STAFF REPORT SAN CLEMENTE PLANNING COMMISSION

Date: May 20, 2020

SUBJECT: **Site Plan Permit (SPP) 19-203, Architectural Permit (AP) 19-204, Conditional Use Permit (CUP) 19-205, Amended Discretionary Sign Permit (AM-DSP) 18-546, 610 Camino De Los Mares; Plaza by the Sea Drive-Through**, a request to demolish a freestanding commercial building and construct a new 4,250 square foot commercial building for two tenants including a drive-through in an existing commercial center at 610 - 628 Camino De Los Mares within a city Gateway and the Community Commercial 4 Zone (CC4). A dividing wall between Plaza by the Sea and neighboring Ocean View Plaza (638 Camino De Los Mares) is proposed to be removed to allow for shared access between the retail centers. The recently approved Master Sign Program is proposed to be updated to include signage for the new building including a drive up menu-board.

Figure 5A: Location of Proposed Wall Removal and Trash Relocation

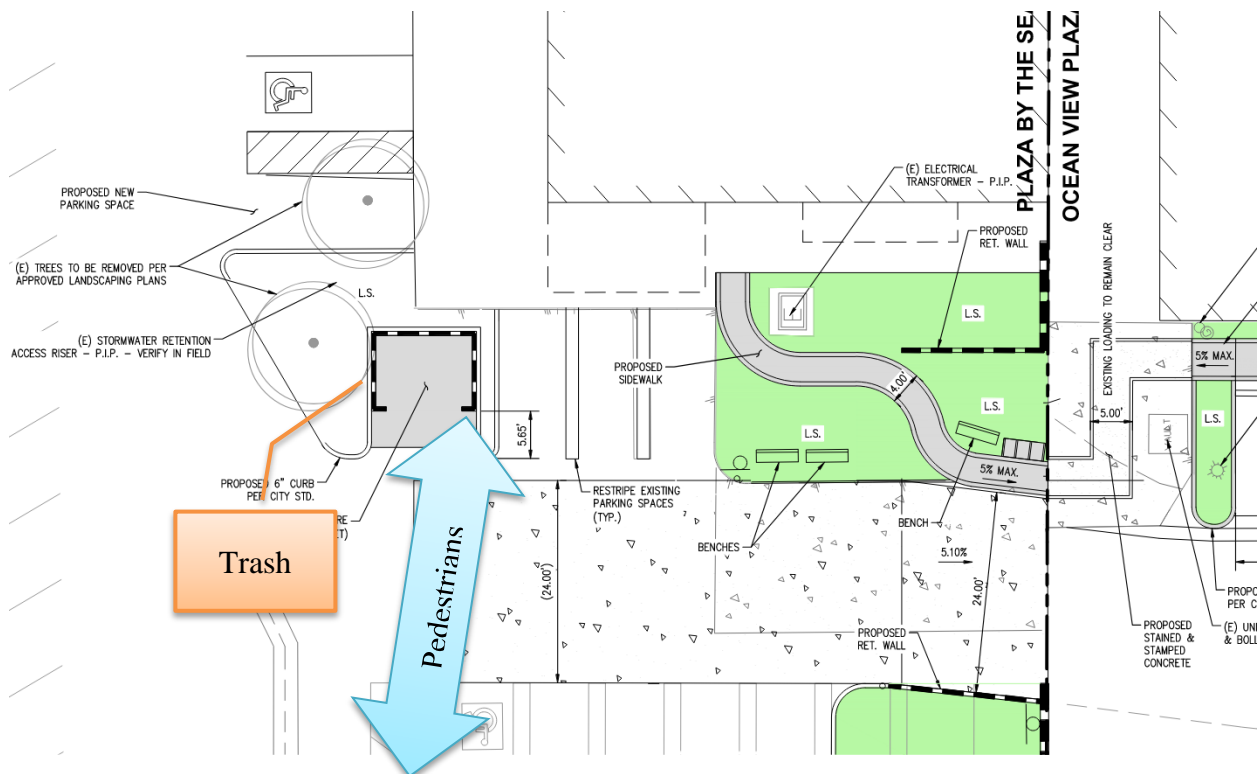
Comment/Recommendation:	Applicant Response:
3. Suggested adding decorative hardscape to the pedestrian connection between both commercial center properties. However, recommended that the drive aisle not use turf block, which would likely be difficult to maintain in a clean condition.	Not addressed. The applicant preferred to maintain consistency with adjacent concrete sidewalks in this area. However, they modified the pedestrian areas around the new outparcel building to include pervious pavers.

SP.1

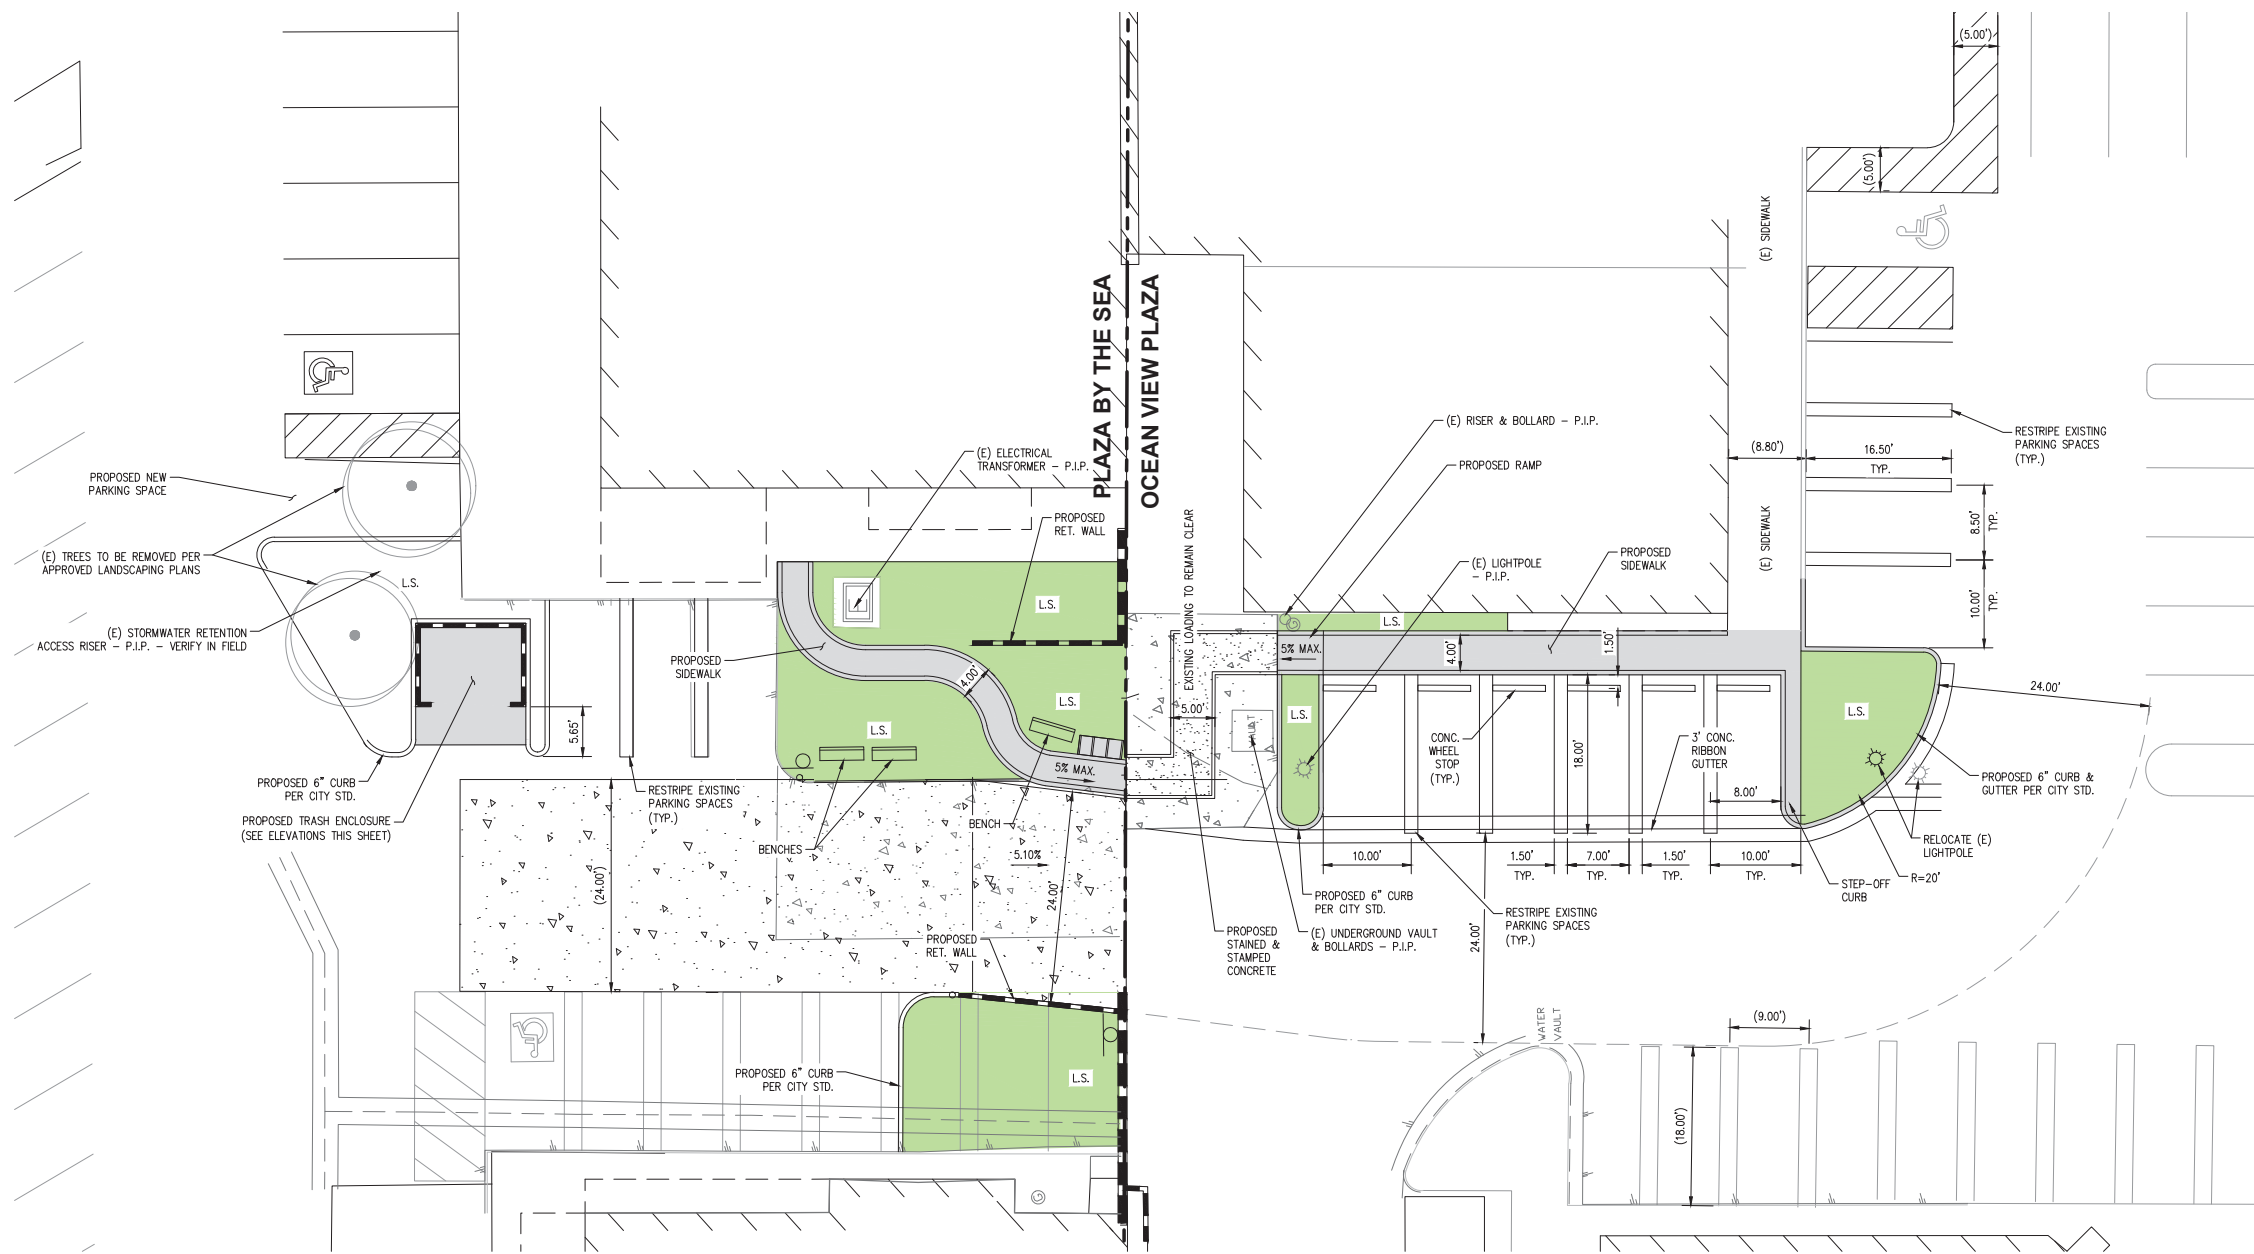
5. Noted that required EVCS parking and related equipment should be shown on the site plan and integrated to minimize the visibility of the equipment.	Addressed. See plan sheet SP.1. Equipment (other than charging unit) shall be mounted to the building behind the stucco wall shown on the northwest elevation.

SP.2

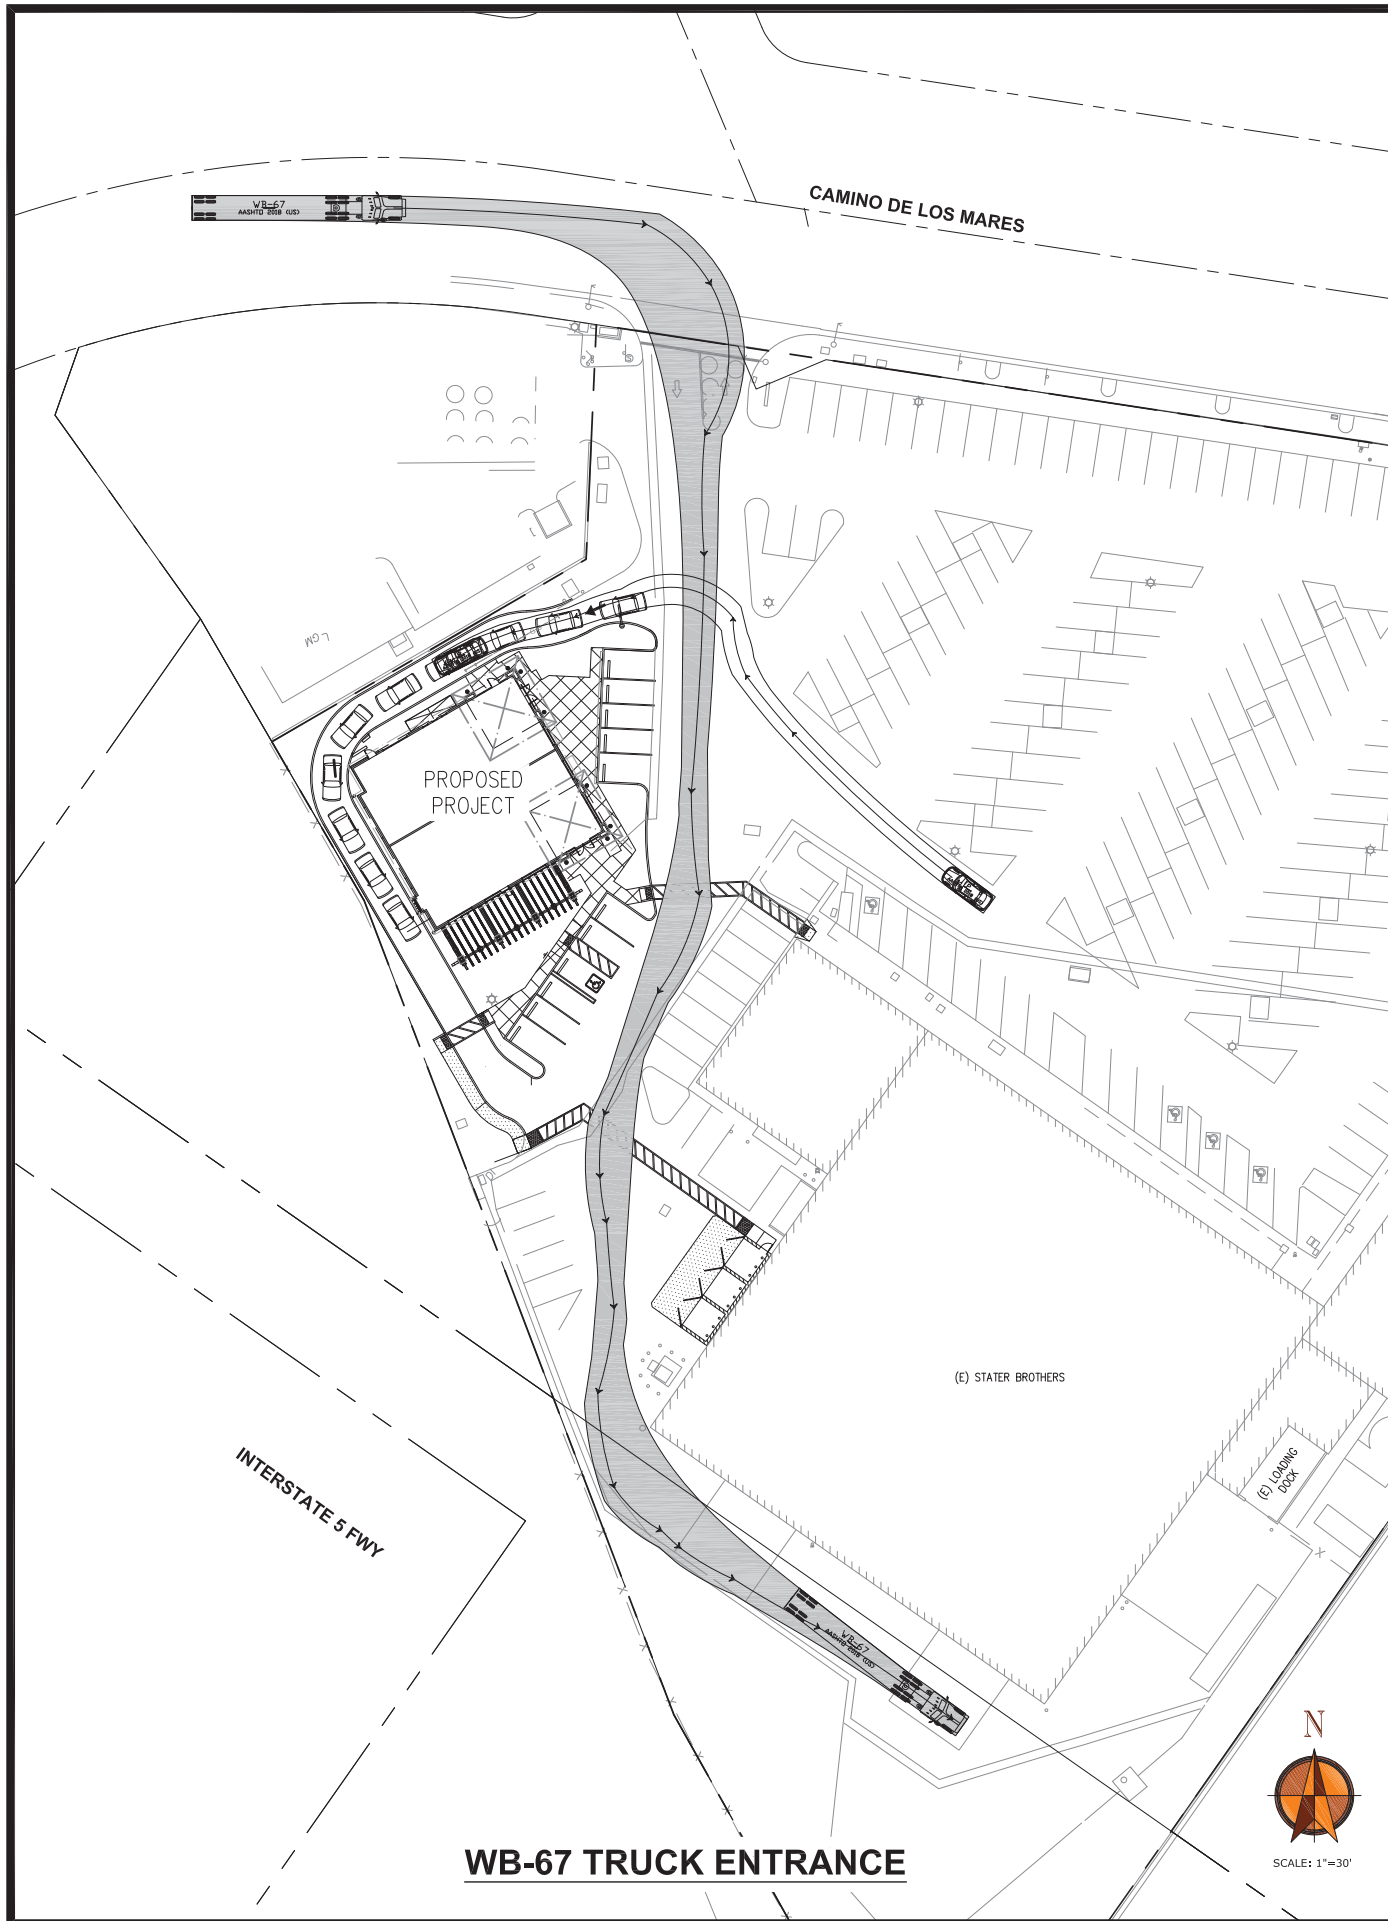
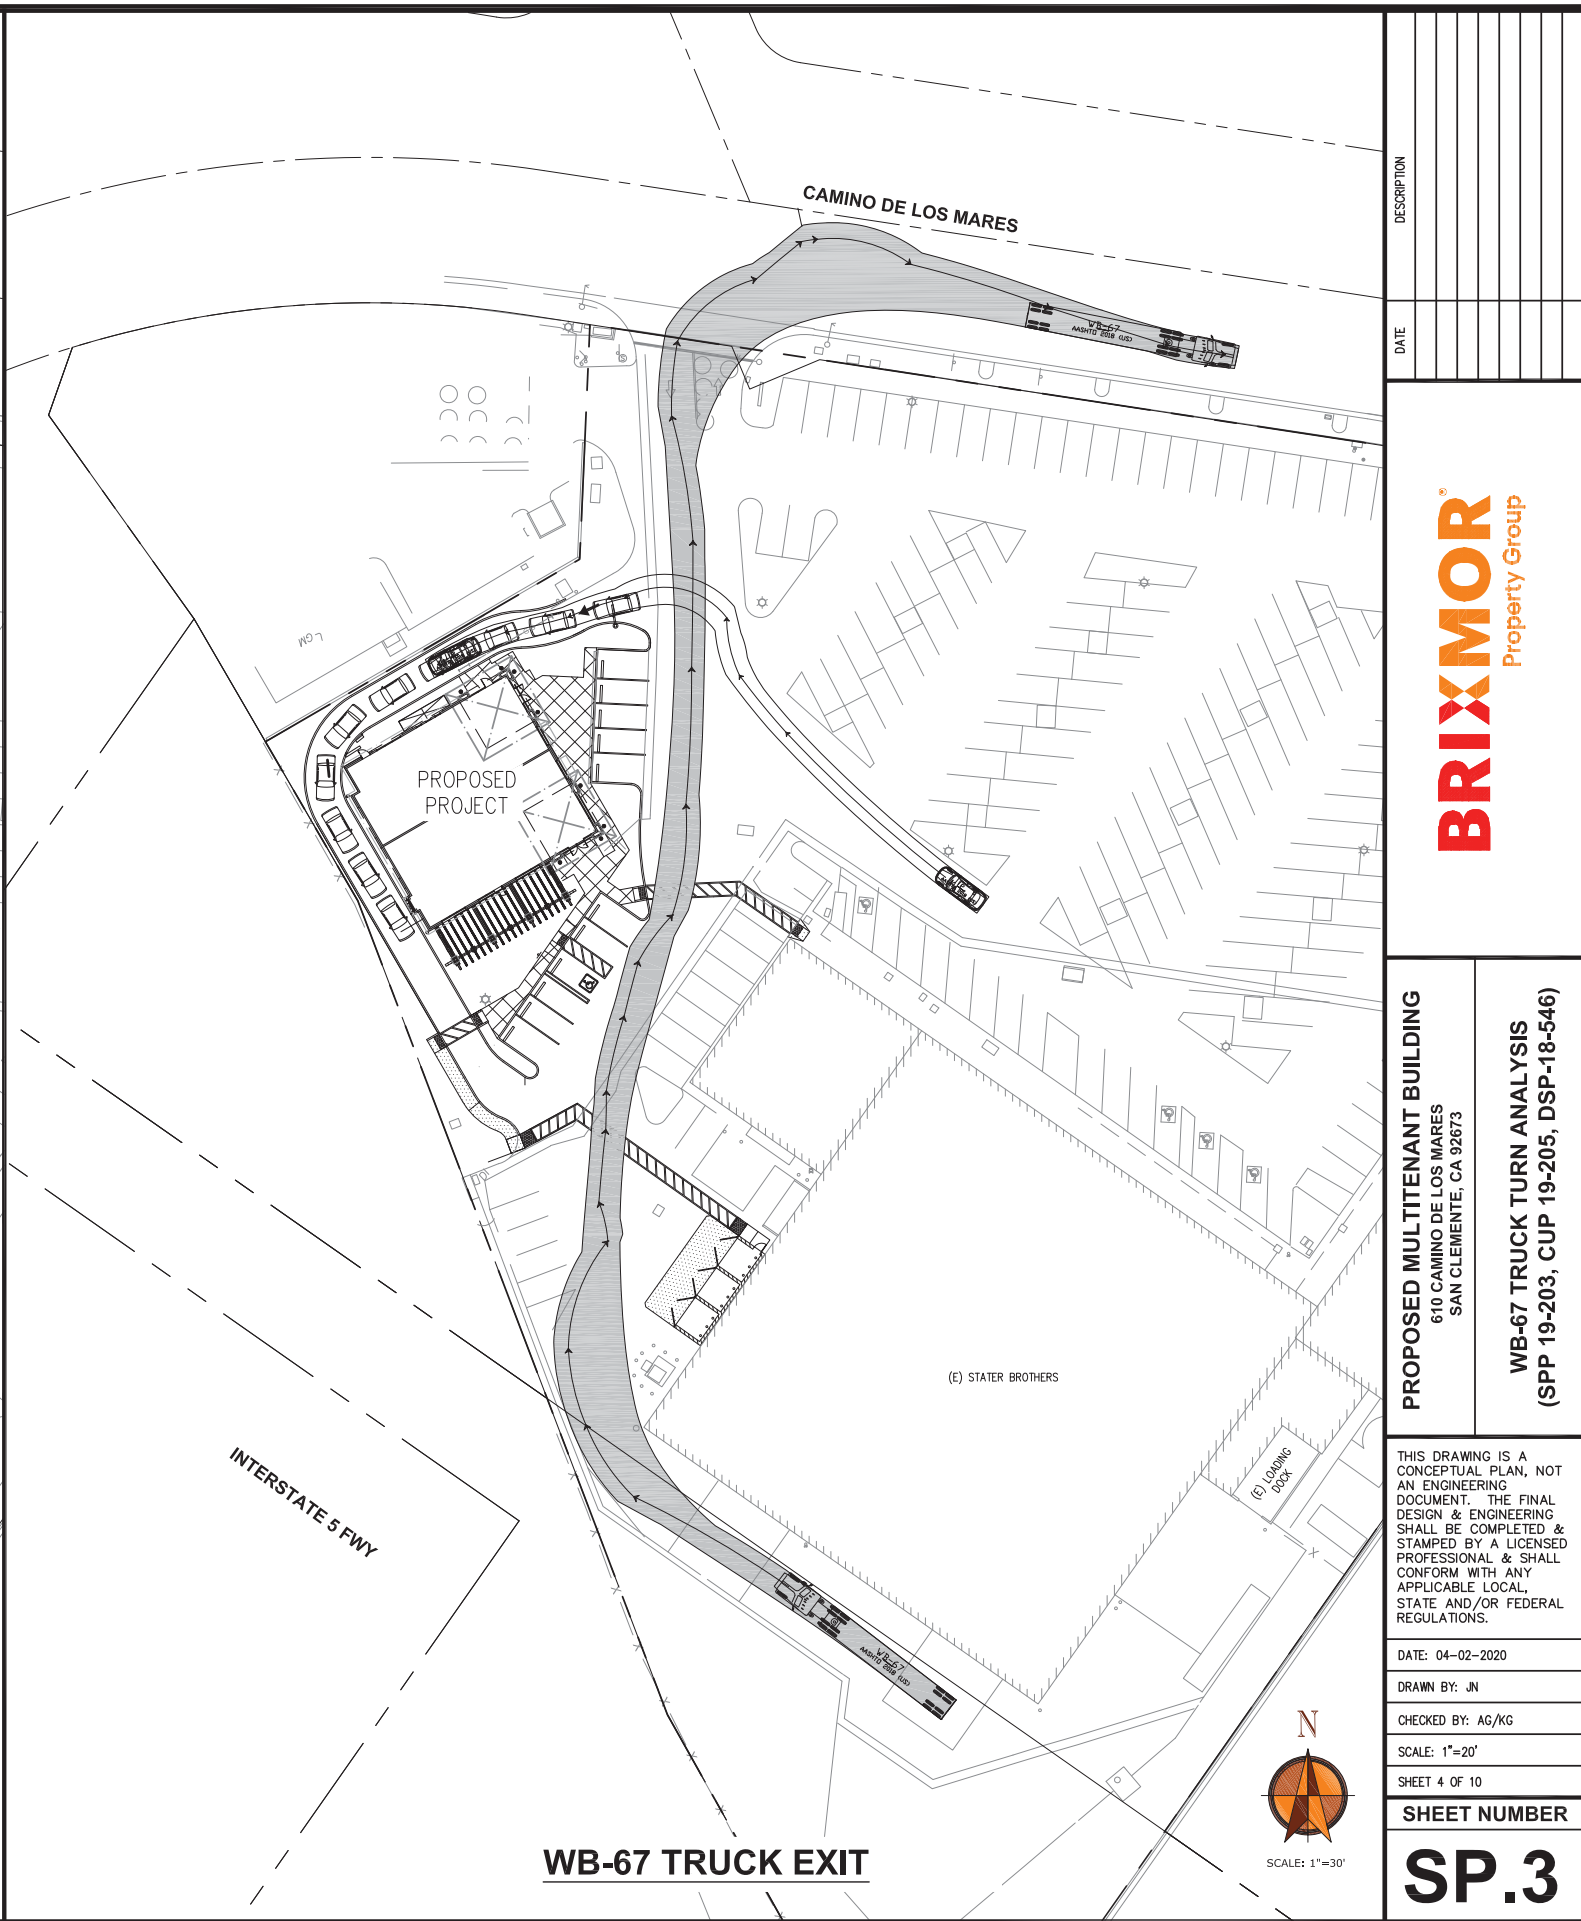
- Discussed the truck turning plan on Sheet SP.3 and expressed concern over potential conflicts with vehicular circulation in the parking lot when a truck is making deliveries to Stater Brothers.
